PART I - PERTAINING TO THE PROJECT MANUAL

End of Addendum Three

CRABAPPLE LANE ELEMENTARY SCHOOL RENOVATION

DUCT PENETRATIONS

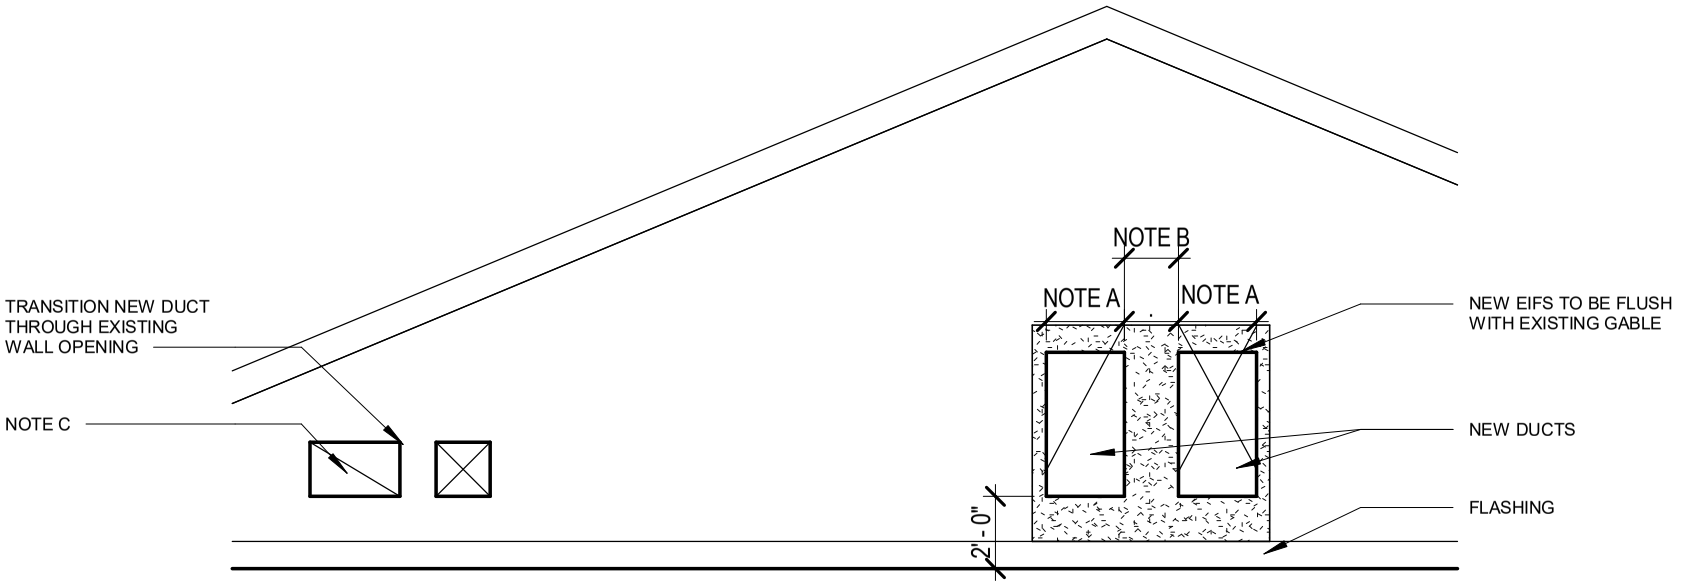
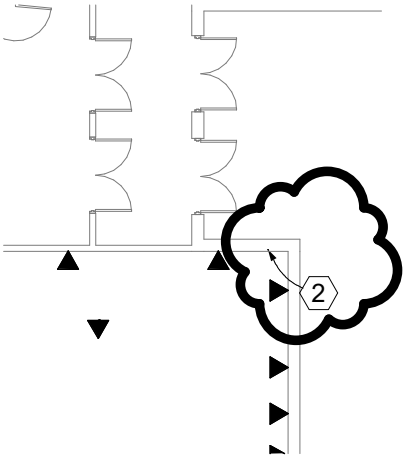
II-A. Sheet A-403: Add Duct Penetration Detail 1D3-A403.1 as indicated in attached Drawing D3-A403.1 dated 10/27/26.

A - OPENING IN EIFS SHALL BE 1" WIDER IN BOTH DIRECTIONS THEN OPENINGS IN RTU UNIT. PROVIDE 1/2" SEALANT JOINT BETWEEN DUCTS AND EIFS, ALL SIDES.
PROVIDE HEAD FLASHING @ ALL PENETRATIONS WITH SEALANT JOIN AT EIFS. SLOPE DUCTS AS REQUIRED TO PITCH WATER AWAY FROM RTU AND COBBLE.

B - OPENINGS SHALL BE SPACED TO MATCH DUCT OPENING ON RTU, SLOPE DUCTS AS REQUIRED TO ALIGN WITH EXISTING OPENINGS.

C - TRANSITION DUCT WORK BETWEEN REPLACEMENT RTU AND EXISTING OPENINGS. SLOPE DUCT WORK TO PROVIDE PITCH WATER FLASHING WITH NEW SEALANT JOINT

BLOCK A - DATA SYSTEMS

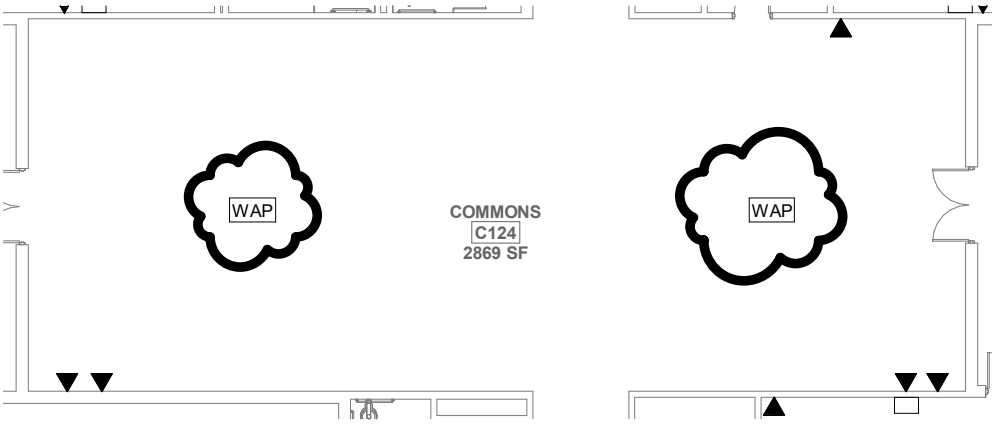
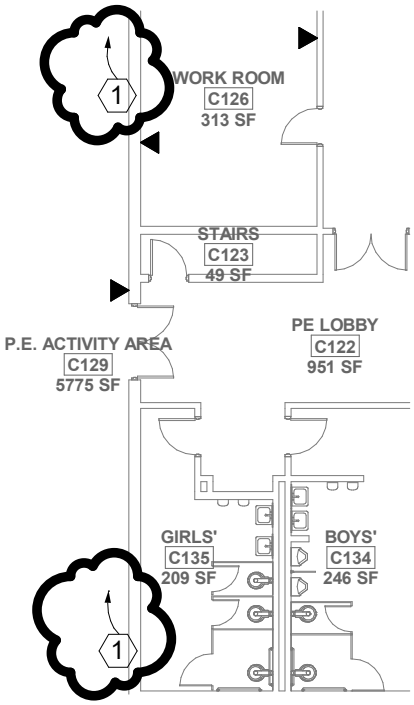
II-C. Sheet E-400 – Add Block A Data Systems details and Keynotes as indicated in attached Drawings D3-E-400.1 dated 10/27/26.

DATA SYSTEMS KEYNOTES	
1	EXISTING EXTERIOR WALL MOUNTED CENTEGIX GATEWAY TO REMAIN. RUN NEW CAT 6e DATA CABLE IN CONDUIT BACK TO THE CLOSEST MDF/IDF ROOM.
2	EXISTING EXTERIOR WALL MOUNTED WAP TO REMAIN. RUN NEW CAT 6a DATA CABLE IN CONDUIT BACK TO THE CLOSEST MDF/IDF ROOM.

1. LOCATION FOR CENTEGIX GATEWAY DEVICE INDICATED BY KEYNOTE 1.
2. LOCATION FOR EXTERIOR WAP INDICATED BY KEYNOTE 2.
3. THE FOLLOWING CLARIFICATION ADDED TO "DATA/Telecommunications General Notes".

1. **CABLING TYPE:** ALL DATA CABLING SHALL BE COMMSCOPE CATEGORY 6e, 4 PAIR, UTP CABLING EXCEPT FOR ALL WAPs WHICH WILL BE CAT6a.

3. IDF/MDF LOCATIONS:
ALL DATA RACKS SHALL BE REPLACED WITH TWO-POST RACKS.

BLOCK C - DATA SYSTEMS

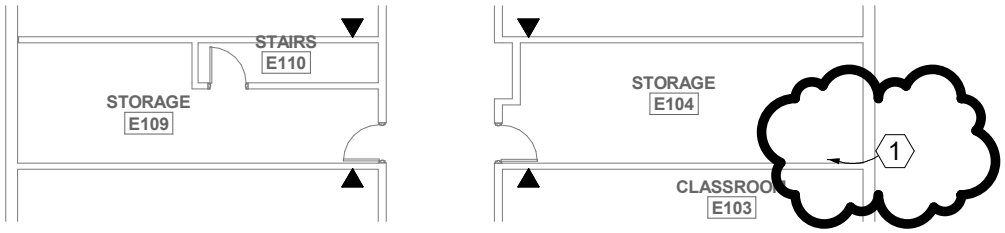
II-D. Sheet E-402 – Add Block C Data Systems details and Keynotes as indicated in attached Drawings D3-E-402.1 dated 10/27/26.

DATA SYSTEMS KEYNOTES	
1	ADD NEW WALL MOUNTED WAP. RUN NEW CAT 6a DATA CABLE IN CONDUIT BACK TO THE CLOSEST MDF/IDF ROOM. COORDINATE THE MOUNTING HEIGHT WITH ARCHITECT PRIOR TO ROUGH IN.

1. TWO ADDITIONAL LOCATIONS INDICATED FOR CEILING MOUNTED WAPs.
2. TWO ADDITIONAL LOCATIONS INDICATED FOR WALL MOUNTED WAPs.

PROJECT NUMBER	DATE	
C08154.005	10/27/26	
ORIGINAL DRAWING REFERENCE	DRAWN BY	APPROVED BY
REF DWG		
RESPONSE TO	THIS SHEET	
ASI	D3-E-404.1

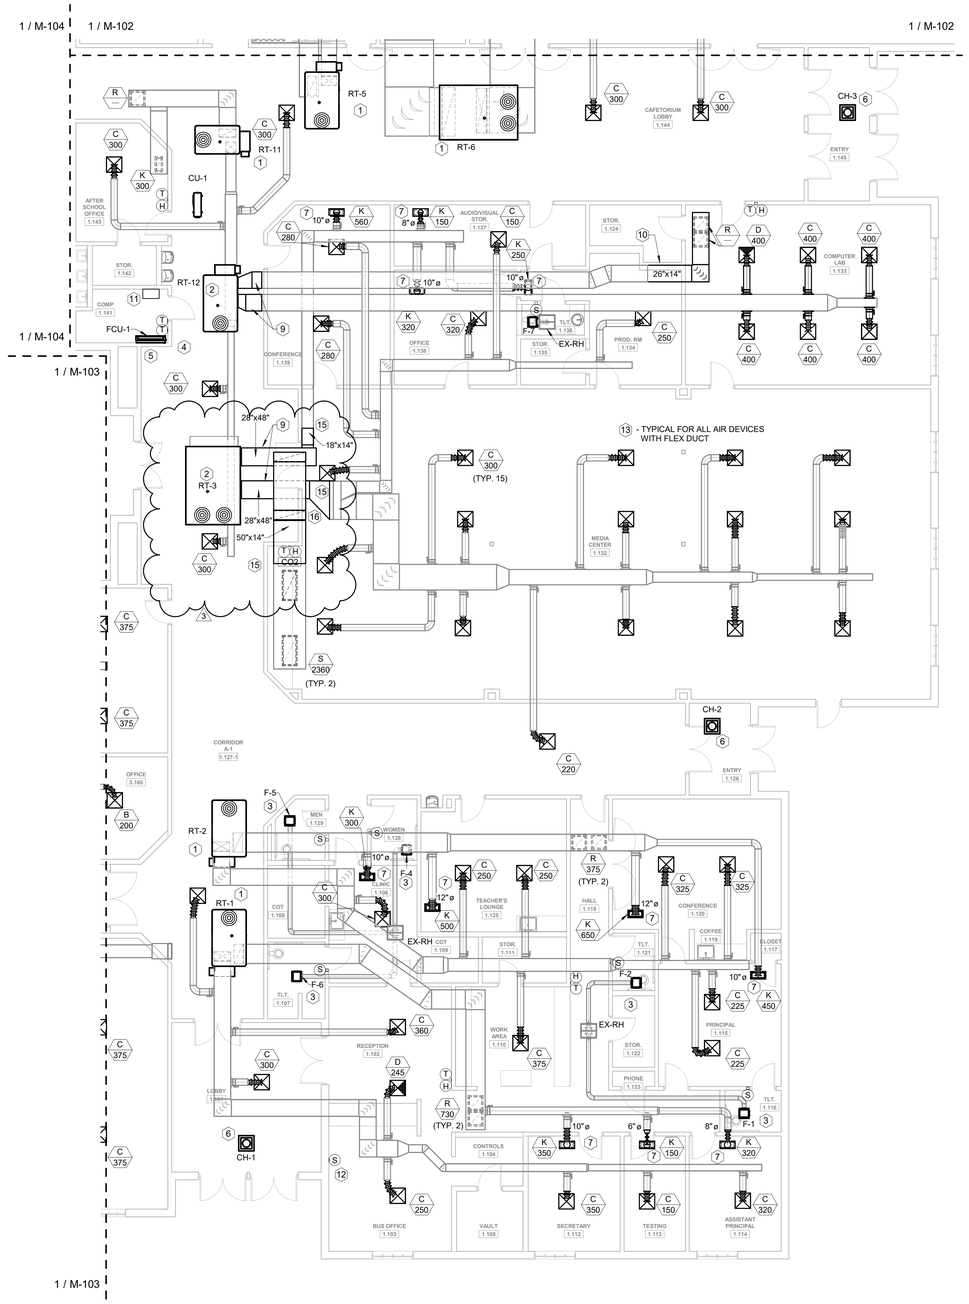
II-E. Sheet E-404 – Add Block E Data Systems details and Keynotes as indicated in attached Drawings D3-E-404.1 dated 10/27/26.

DATA SYSTEMS KEYNOTES	
1	EXISTING EXTERIOR WALL MOUNTED CENTEGIX GATEWAY TO REMAIN. RUN NEW CAT 6e DATA CABLE IN CONDUIT BACK TO THE CLOSEST MDF/IDF ROOM.

1. LOCATION FOR CENTEGIX GATEWAY DEVICE INDICATED BY KEYNOTE 1.

DRAWING NO.
M-101

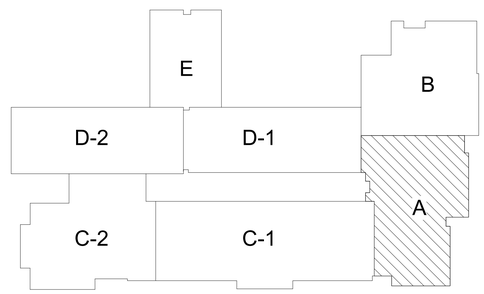
07/06/26	DOE REVIEW SET
	07/28/26	BID SET
3	10/27/26	ADDENDUM THREE

1. RTU SHALL BE MOUNTED ON AN ADAPTER CURB - CONTRACTOR SHALL FIELD VERIFY EXISTING CONDITIONS AND PROVIDE SHOP DRAWINGS OF ADAPTER CURB PRIOR TO ORDERING. NEW AIR DISTRIBUTION DEVICES AND FLEX DUCT SHALL CONNECT TO EXISTING SUPPLY DUCT BRANCH - CONTRACTOR SHALL FIELD VERIFY EXISTING BRANCH SIZE. SEE "AIR DISTRIBUTION SYSTEM" SCHEDULE FOR CORRESPONDING DUCT SIZES - TRANSITIONS SHALL BE PROVIDED AS REQUIRED TO CONNECT EXISTING BRANCH TO NEW FLEX DUCT. NEW RETURN GRILLES AND ASSOCIATED DUCT SHALL BE MOUNTED IN CEILING GRID - CONNECT DUCT TO EXISTING RETURN DUCT MAIN. NEW 2" PLEATED MERV 10 FILTERS SHALL BE PROVIDED - CONTRACTOR SHALL PROVIDE FILTERS FOR STARTUP SET AND ONE REPLACEMENT SET.

2. RTU SHALL BE MOUNTED ON AN ADAPTER CURB - CONTRACTOR SHALL FIELD VERIFY EXISTING CONDITIONS AND PROVIDE SHOP DRAWINGS OF ADAPTER CURB PRIOR TO ORDERING. CONTRACTOR SHALL COORDINATE THE CURB ADAPTER PROVIDES 16" CLEARANCE BETWEEN THE ROOF AND BOTTOM OF HORIZONTAL EXTERIOR DUCTWORK. NEW EXTERIOR DUCTWORK SHALL CONNECT TO EXISTING AT WALL PENETRATION. EXISTING DUCTWORK SHALL BE MODIFIED / REPLACED AS REQUIRED TO MATCH THE REPLACEMENT UNIT'S DUCTWORK CONNECTION CONFIGURATION. NEW AIR DISTRIBUTION DEVICES AND FLEX DUCT SHALL CONNECT TO EXISTING SUPPLY DUCT BRANCH - CONTRACTOR SHALL FIELD VERIFY EXISTING BRANCH SIZE. SEE "AIR DISTRIBUTION SYSTEM" SCHEDULE FOR CORRESPONDING DUCT SIZES - TRANSITIONS SHALL BE PROVIDED AS REQUIRED TO CONNECT EXISTING BRANCH TO NEW FLEX DUCT. NEW RETURN GRILLES AND ASSOCIATED DUCT SHALL BE MOUNTED IN CEILING GRID. NEW 2" PLEATED MERV 10 FILTERS SHALL BE PROVIDED - CONTRACTOR SHALL PROVIDE FILTERS FOR STARTUP SET AND ONE REPLACEMENT SET.

7. TRANSITION SHALL CONNECT TO EXISTING DUCT AS REQUIRED - ROUTE FLEX DUCT TO AIR DEVICE.
8. NOT USED.
9. NEW EXTERIOR DUCT SHALL BE ROUTED THROUGH EXISTING WALL OPENING - EXTERIOR DUCT SHALL BE DOUBLE WALL AND PAINTED. NEW DUCT SHALL CONNECT TO THE EXISTING DUCTWORK. EXISTING DUCT CONFIGURATION IS TOP SUPPLY AND BOTTOM RETURN. NEW RTU CONNECTION CONFIGURATION IS SIDE-BY-SIDE. THE NEW DUCTWORK SHALL ENTER THE BUILDING THROUGH THE EXISTING WALL OPENING AND TRANSITION AND CONNECT TO THE EXISTING DUCTWORK INSIDE THE BUILDING.
